National Committee on **Uniform Traffic Control Devices**

NCUTCD Proposal for Changes to the **Manual on Uniform Traffic Control Devices**

ITEM NUMBER: 20A-GMI-01

Publicly Accessible Off-Street Parking General Service TOPIC:

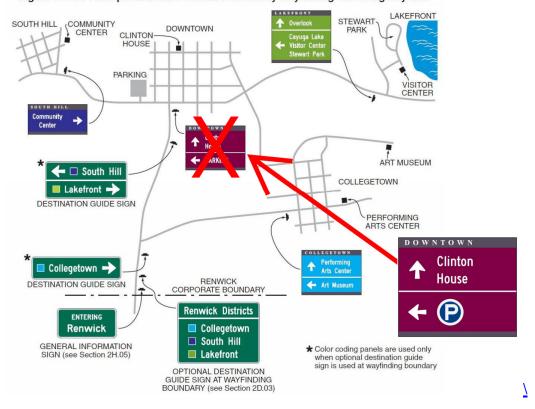
- 211 Guidance:
- 212 37a When used on community wayfinding signs, publicly accessible parking wayfinding should 213 use the parking symbol (see Section 2I.02 and refer to Figures 2D-19 and 2D-20).

218 Modify Figures 2D-19 and 2D-20 as shown below
